**Rationale for Recommended Rejection of the
Vitzhum Gulch Rehabilitation Site as one of the 44
Record of Decision Channel Rehabilitation Sites
Implemented by the
Trinity River Restoration Program**

Hoopa Valley Tribal Council

Hoopa Valley Tribe Fisheries Department

December 17, 2007

Figure 2. Intended treatment approach in the TRFEFR for “forced meander channel rehabilitations” as recommended at Vitzhum Gulch (Figure 8.16 in TRFEFR)

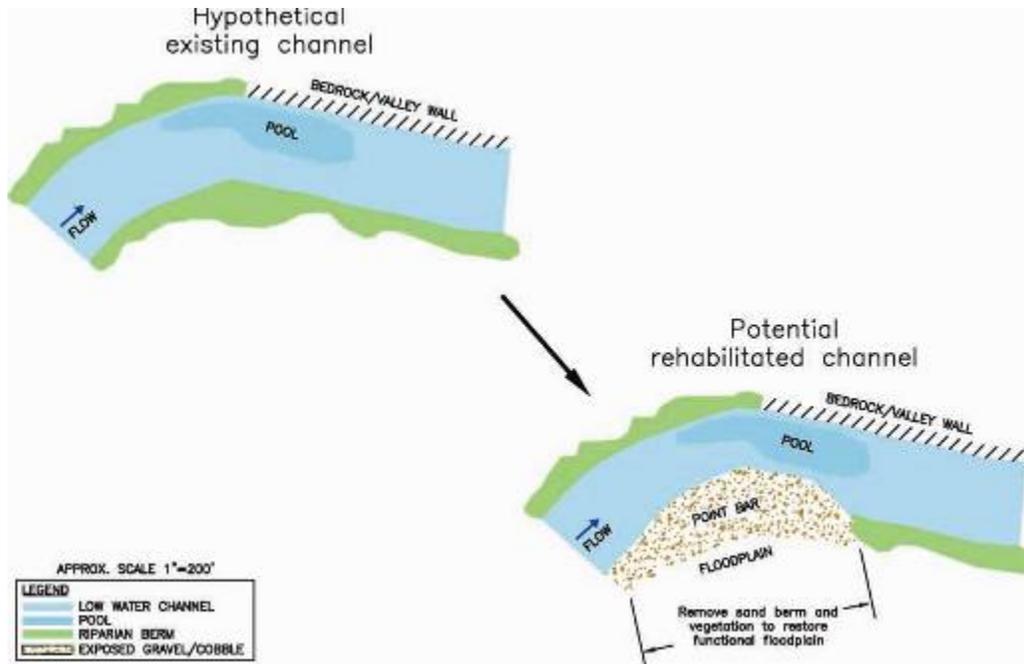
As described in Section 8.1 of the TRFEFR and illustrated in Figures 8.16 and 8.17 in the TRFEFR (Figures 2 and 3), channel rehabilitation at the Vitzhum Gulch site would have removed the sand berm and vegetation, restored point bars, added coarse sediment, restored a functional floodplain on the inside of the bend, and revegetated constructed floodplains with native riparian vegetation; the result expected from these actions would be substantial, long-term improvements to fish production. As shown in Figure 4, the TRRP implemented a berm notching design at the Vitzhum Gulch site, despite strong objection from the Fisheries Department, USFWS, and the Bureau of Reclamation Value Engineering Study, that deviates from the design approach dictated in the TRFEFR and ROD. The berm notching design does not remove most of the riparian berm, nor enable the river to resize itself and create complex channel morphology, thus represents a “pin prick” in restoring habitat rather than the overhaul intended in the TRFEFR and ROD. If the entire berm would have been removed, the underlying floodplain would have also been restored as envisioned in the TRFEFR. Instead, large swaths of the riparian berm were left in place and the floodplain was not restored. This will likely prevent a complex channel morphology to form in this reach. Berm notching also precluded any riparian replanting that would have occurred on the upland areas of a restored floodplain, should one have been built, as outlined in the TRFEFR.. The TRRP does not have discretion to deviate from the channel rehabilitation approach developed in the TRFEFR and adopted by the ROD.

Figure 4. Rehabilitation design that was implemented at the Vitzhum Gulch bank rehabilitation site in fall 2007. Note “berm notching” approach rather than the complete berm removal dictated by the TRFEFR and ROD

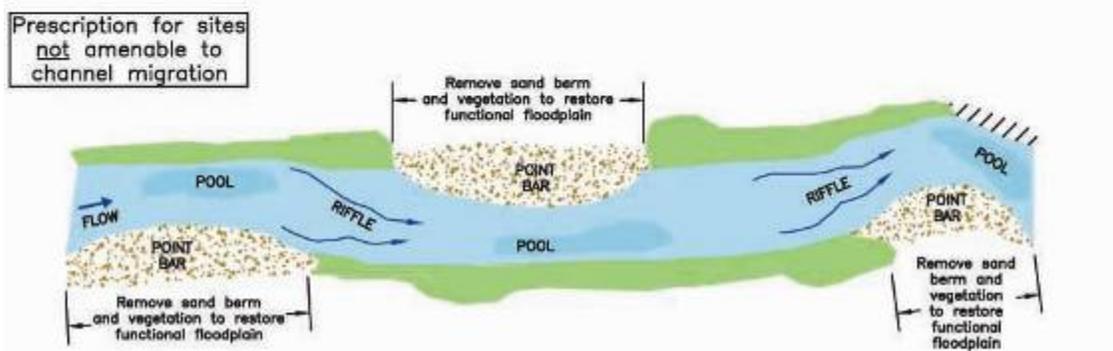
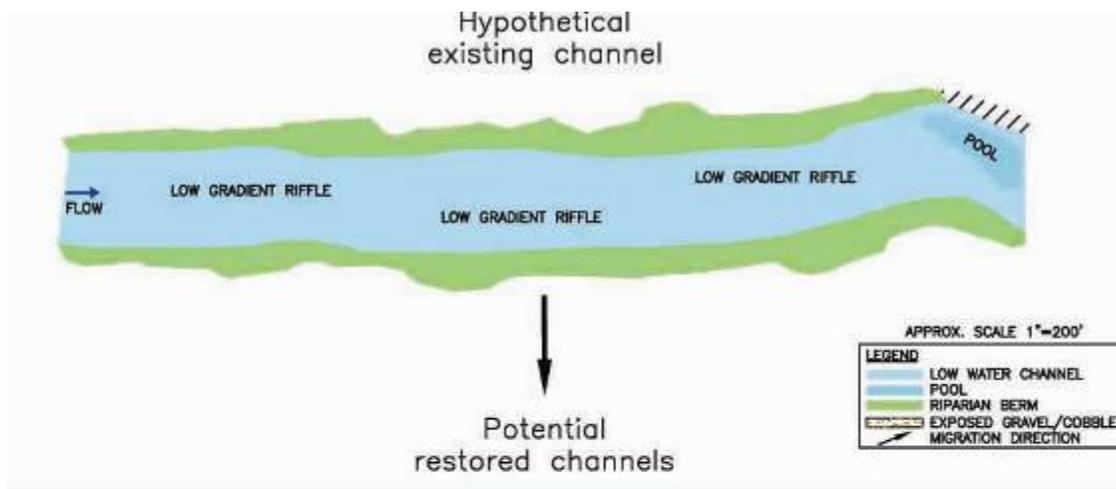
There is been no evidence supplied to indicate berm notching at Vitzhum Gulch is a superior and more productive alternative to what was adopted in the ROD, let alone evidence that the experiment would even work at all. The TRRP should have the burden of proof responsibility to provide strong evidence on why the berm notching experiment at Vitzhum Gulch was likely to succeed, but did not do so.

Figure 6. Trinity River at Hocker Flat, post-construction, and post 17,000 cfs flow. Note that riparian encroachment remains in place despite being fully exposed to high flows that are greater magnitude than maximum ROD releases (11,000 cfs).

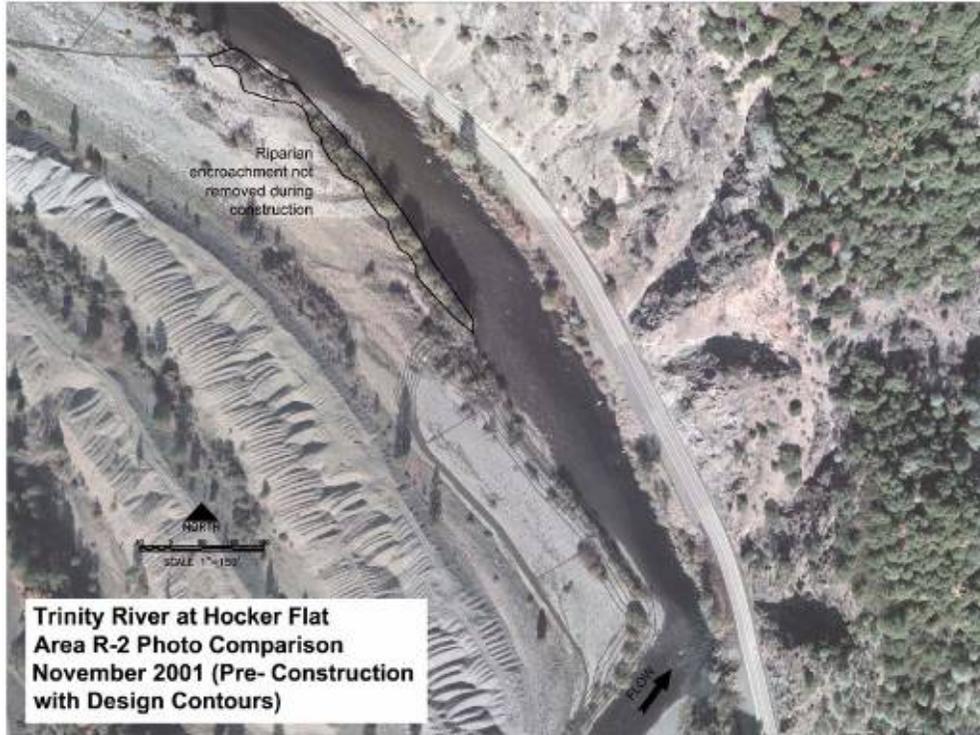
Implemented in September and October 2005, the Hocker Flat channel rehabilitation site was subjected to a 17,000 cfs peak flow on December 31, 2005. Photographic evidence of the upstream portion of the Hocker Flat shows that the riparian encroachment left standing after the mechanical restoration effort withstood the flood. The riparian berm and its community of trees and brush remained intact. As compared to Vitzhum Gulch, Hocker Flat has 1) larger peak flows (17,000 cfs versus 11,000 cfs), 2) a much larger supply of coarse sediment, and 3) a greater transport of large wood during peak flows, all of which should make Hocker Flat riparian vegetation more prone to removal by high water than at Vitzhum Gulch. Therefore, data from Hocker Flat predicts failure of the Vitzhum Gulch design (Figures 5 and 6).
